# Downtown Knoxville Design Overlay District Certificate of Appropriateness

**File Number:** 3-B-14-DT *rev.*

<b>PRE-APPLICATION CONFERENCE</b>		Date Completed: <u>3.4.2014</u>
<p style="text-align: center;"><b>PROPERTY INFORMATION</b></p> <p><b>Building or Project Name:</b> Walnut Street Garage</p> <p><b>Street Address:</b> 400 Locust St</p> <p><b>Parcel Identification Number(s):</b> 94 L H 019.03</p>		<p style="text-align: center;"><b>PROJECT ARCHITECT/ENGINEER</b></p> <p>Andy Powers                  404 Bearden Park Cir                  Knoxville, TN 37919                  Telephone: _____ Fax: 602-7742                  Email: apowers@georgeewart.com</p>
<p style="text-align: center;"><b>PROPERTY OWNER</b></p> <p>Walnut Street Garage, LLC                  520 W Summit Hill Dr Suite 1201                  Knoxville, TN 37902                  Telephone: 546-7020 Fax: 971-4881                  Email: scottiefrl@aol.com</p>		<p style="text-align: center;"><b>PROJECT CONTRACTOR</b></p>
<p style="text-align: center;"><b>ACCOMPANYING MATERIALS</b></p> <p>Please see the second page of this form for a list of information required as part of this application.</p>

**Re: Downtown Design R

**A1.1**

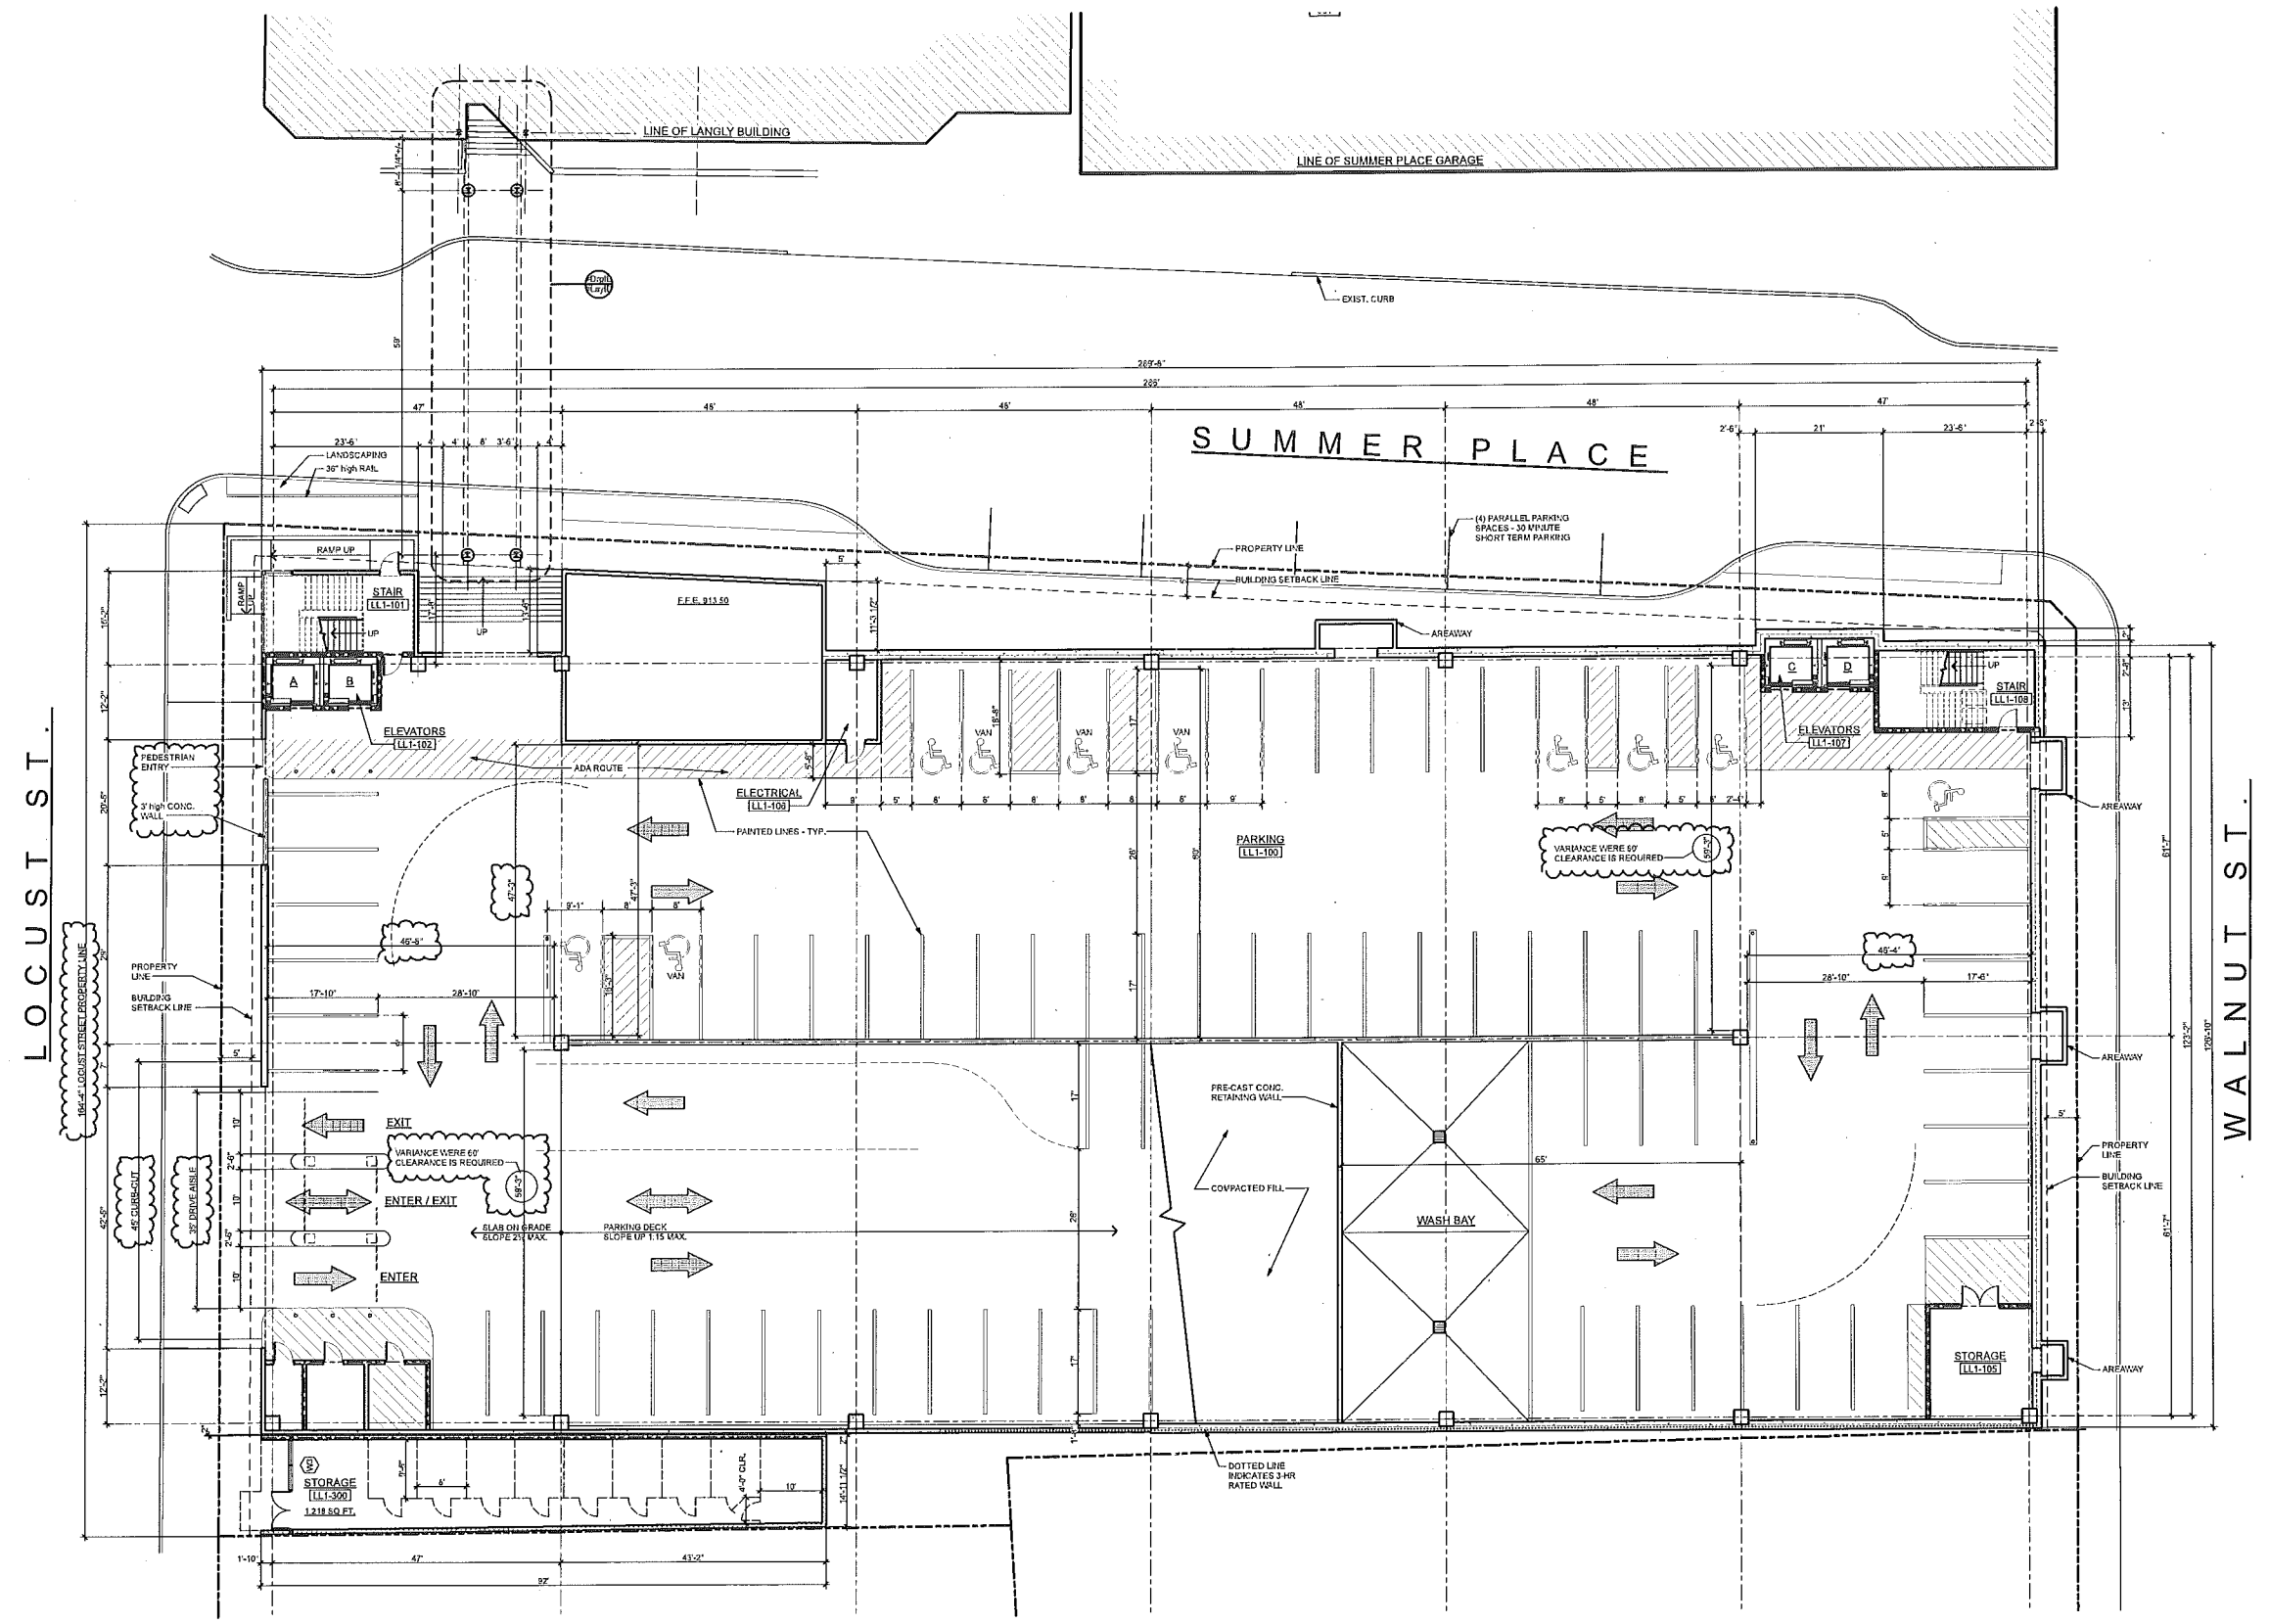
The new design provides two entry/exit bays, one each on Walnut and Locust (see attached A1.1 & A1.2). Each bay contains three lanes. The right lane will be permanently in, the left lane permanently out, and the center lane will be flexible and signed to accommodate peak flow.

The current scheme provides two entry/exit bays, one each on Walnut and Locust (see attached A1.1 & A1.2). Each bay contains three lanes. The right lane will be permanently in, the left lane, permanently out, and the center lane will be flexible and signed to accommodate peak flow. Our parking consultant has reviewed this design and agrees that it provides significant improvements (see attached report).

1 SUMMER PLACE ELEVATION  
 SCALE: 3/32" = 1'-0"

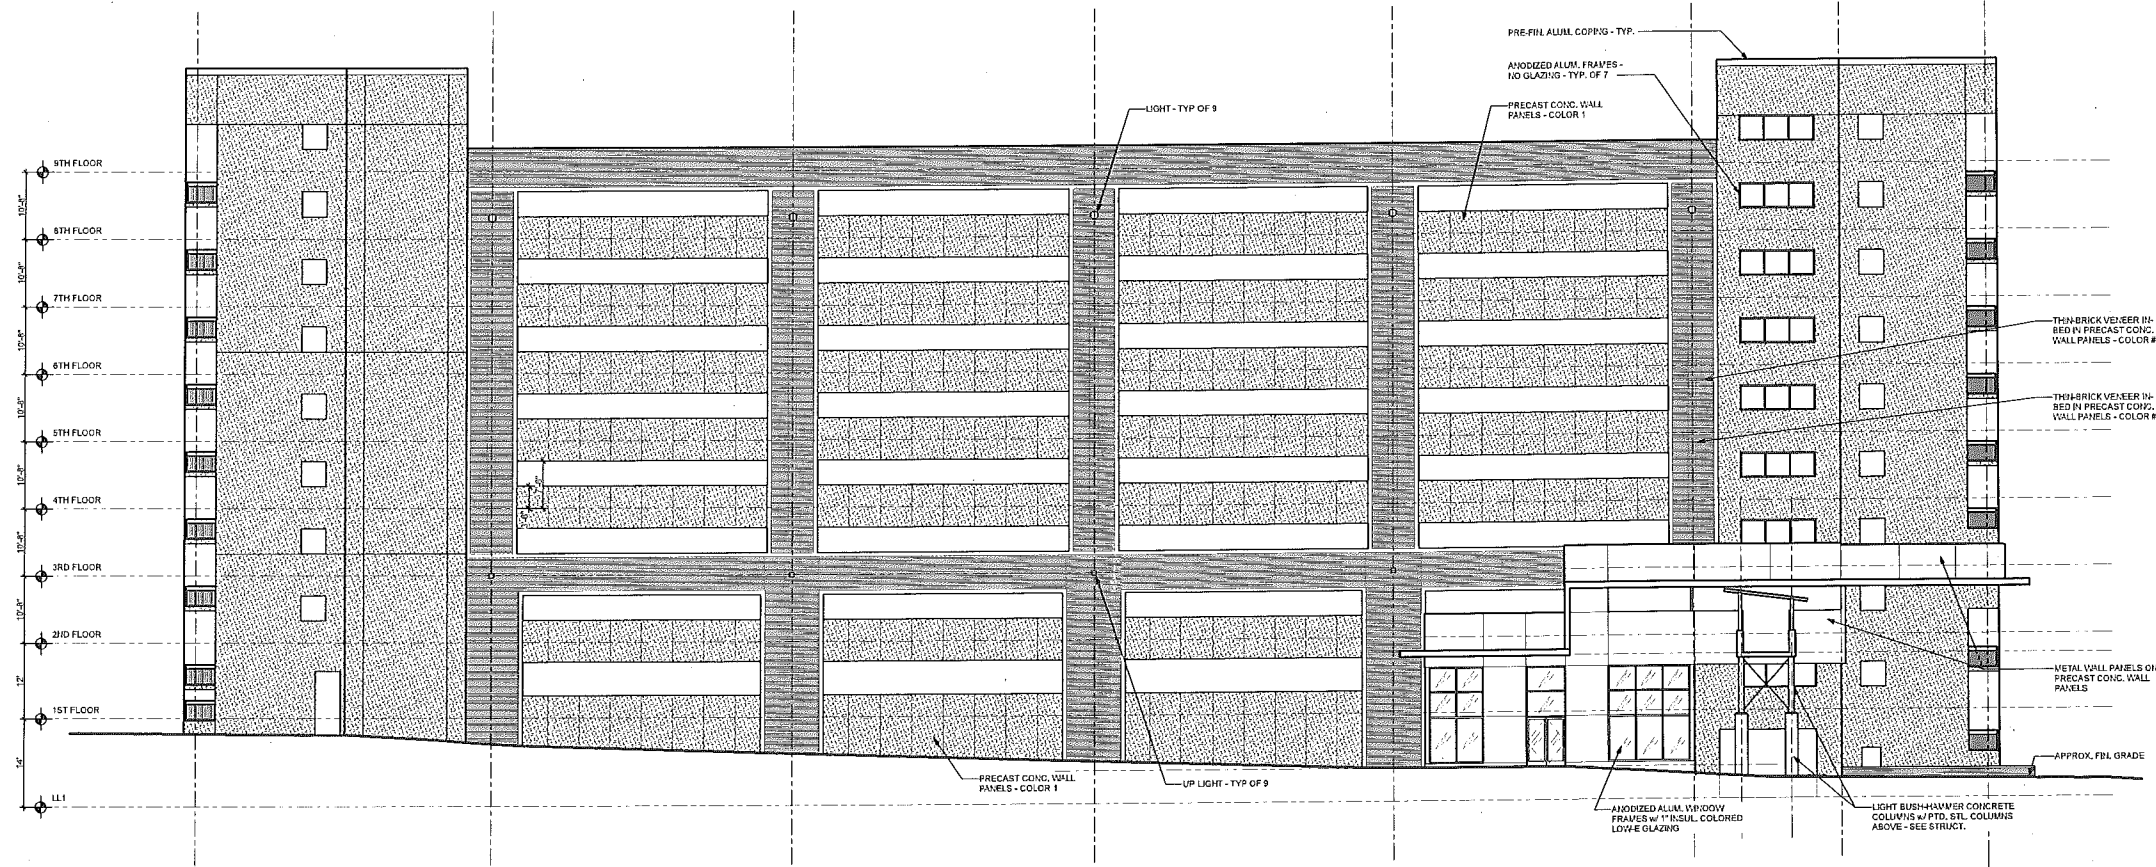
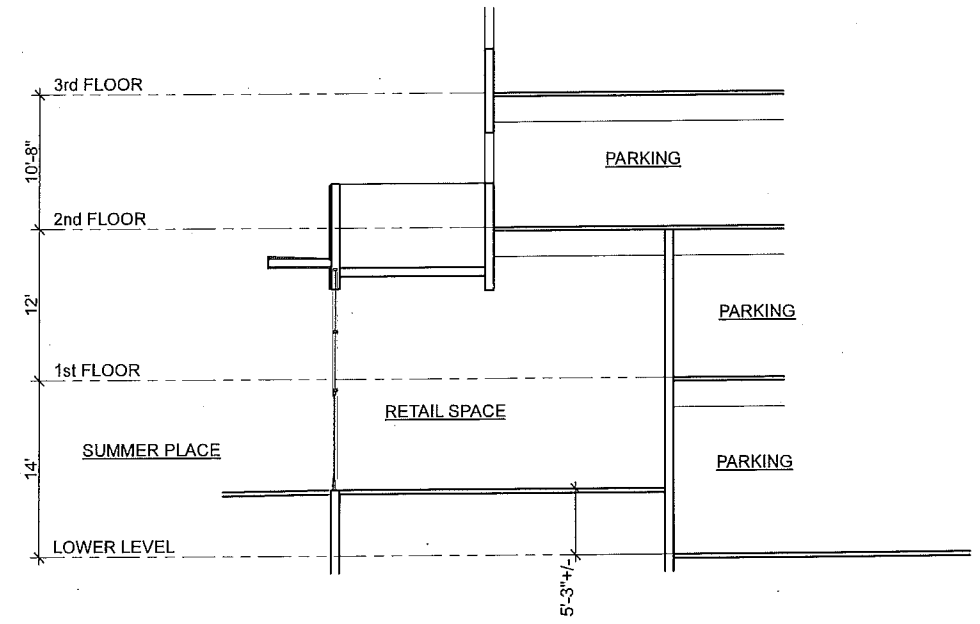
The re-submission also illustrates the Committee's instruction to raise the Summer Place retail to grade level (see attached A3.1). There have been no other design or material changes from what was previously presented. The windows to the west of the retail (above the steps) were shown on the original submission in plan and elevation. They were not shaded to avoid graphic confusion.

**A3.2**

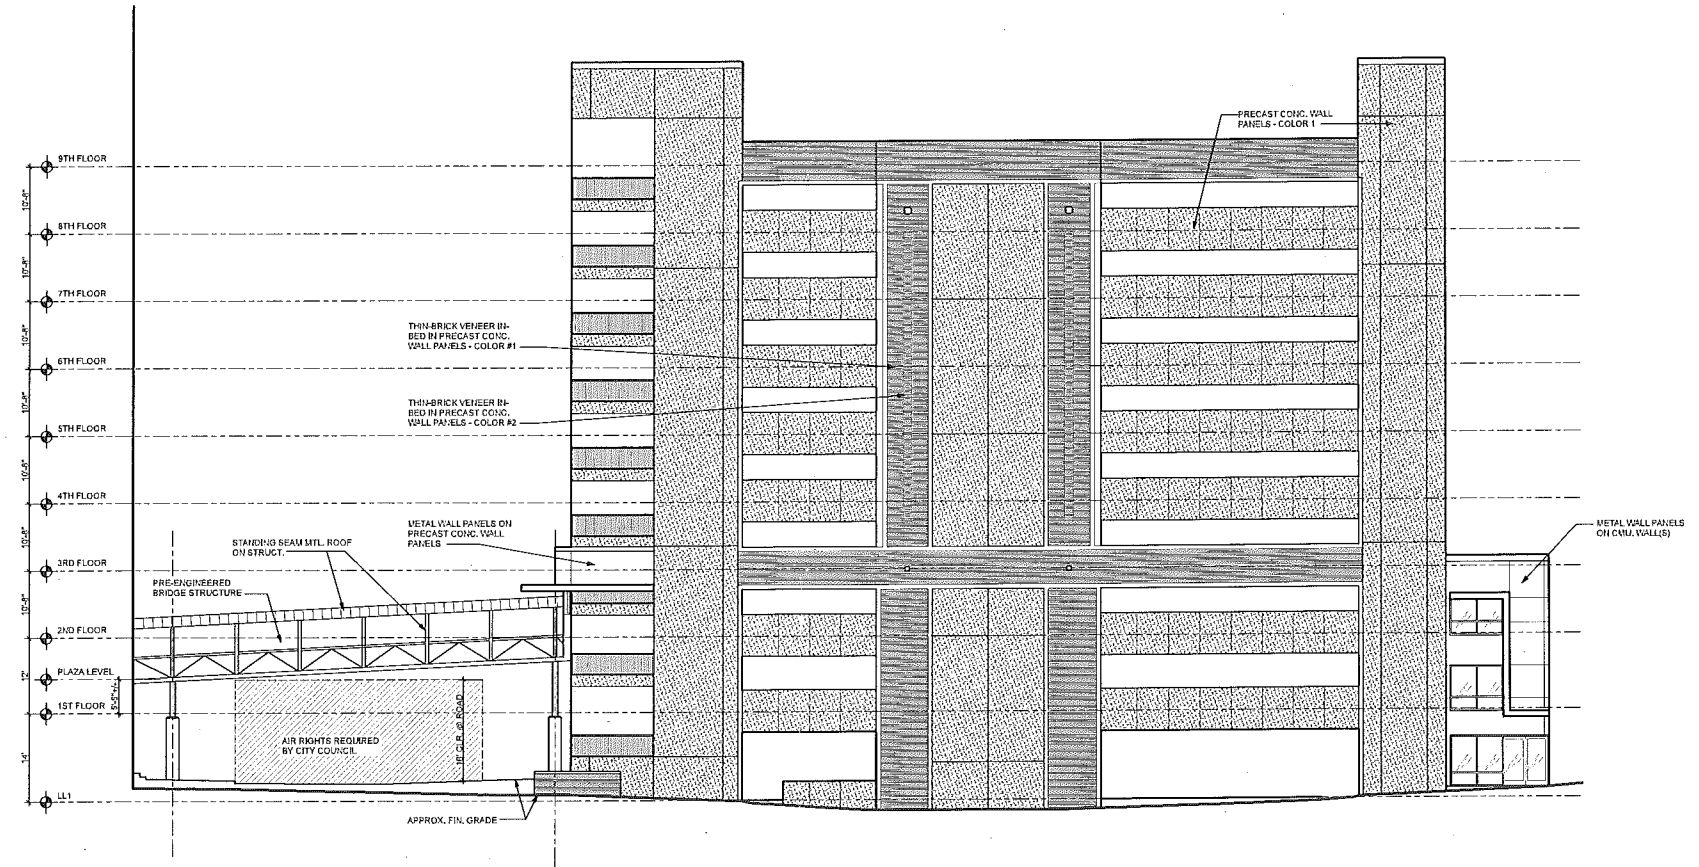
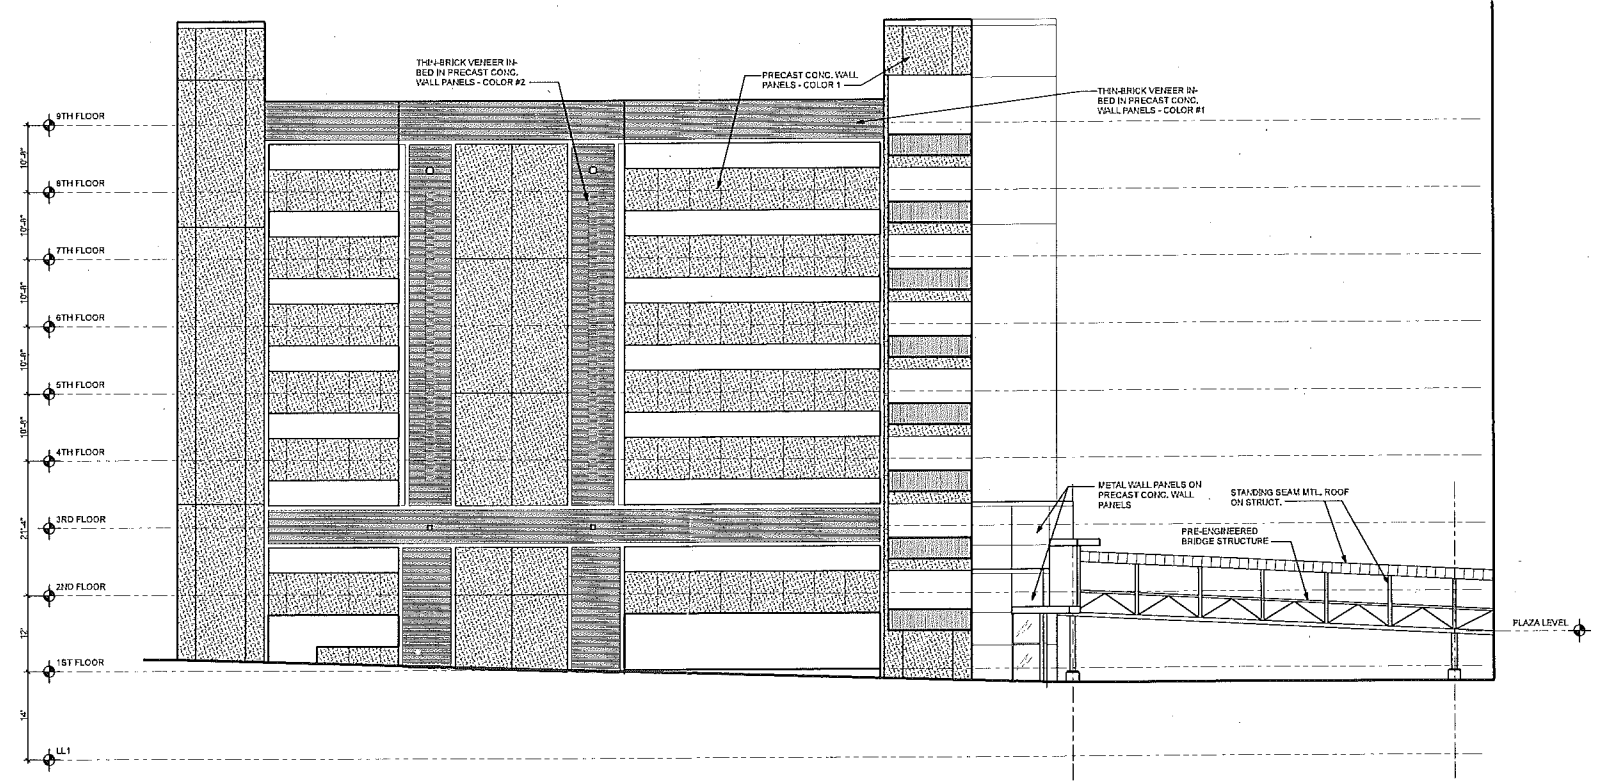
This change involves the Locust and Walnut elevations. The shear wall has been shifted off center to align the entrances with interior traffic lanes and to provide sufficient lateral stability. There is a 3-foot tall, precast wall to screen the view of cars at street level (see attached A3.2).

This change involves the Locust and Walnut Elevations. The shear wall has been shifted off center to align the entrances with interior traffic lanes and to provide sufficient lateral stability. We have provided a 3' tall, precast wall to screen the view of cars at street level (see attached A3.2).
